Access Compliance Report

Public Rights-of-Way

Intersection ID: 14278	Main Street: ROMARE_BEARDEN_DR	Cross Street: FARMER_ST	Location:	N
ADA ID: F5B135B2FE66	Ramp Type: MedianPerp	Initial Pass/Fail: Fail	Overall Compliance: No	Severity Score: 13.75
Codes/Mitigation Info/Possible Solution		Field Measurements/Component Compliance

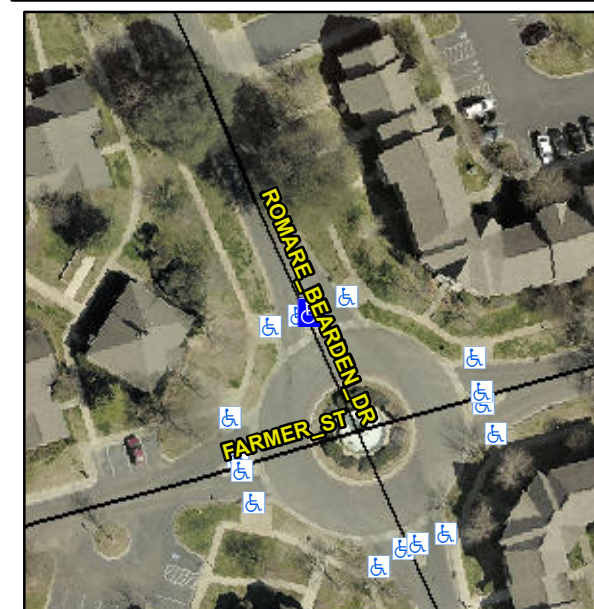
Not Found, R304.2.2, R304.5.3

Compliance	Description	Data	Compliance	Description	Data
N/A	Ramp Length (in)	40.0	No	Ramp Slope (%)	9.0
Yes	Ramp Width (in)	48.0	No	Ramp XSlope (%)	3.3
N/A	Flare Type LT	N/A	N/A	Flare Type RT	N/A
N/A	Flare Slope LT (%)	N/A	N/A	Flare Slope RT (%)	N/A
N/A	Flare Traversable LT?	N/A	N/A	Flare Traversable RT?	N/A
N/A	Landing Length (in)	N/A	N/A	DWS Provided?	N/A
N/A	Landing Width (in)	N/A	N/A	DWS Contrast?	N/A
N/A	Landing Slope (%)	N/A	N/A	DWS Length (in)	N/A
N/A	Landing X Slope (%)	N/A	N/A	DWS Full Width?	N/A
N/A	Landing Curb? (Y/N)	N/A	N/A	DWS Offset (in)	N/A
N/A	Shared Landing?	N/A			
N/A	Gutter Ponding?	N/A	N/A	Gutter Slope (%)	N/A
N/A	Gutter Lip Ht (in)	N/A	N/A	Gutter X Slope (%)	N/A
N/A	Painted X Walk1?	No	N/A	Painted X Walk2?	N/A
	X Walk 1 Direction	To E		X Walk 2 Direction	N/A
N/A	X Walk 1 Width (in)	N/A	N/A	X Walk 2 Width (in)	N/A
	X Walk 1 Slope (%)	0.7		X Walk 2 Slope (%)	N/A
	X Walk 1 X Slope (%)	2.0		X Walk 2 X Slope (%)	N/A

Remove & Replace Entire Ramp.
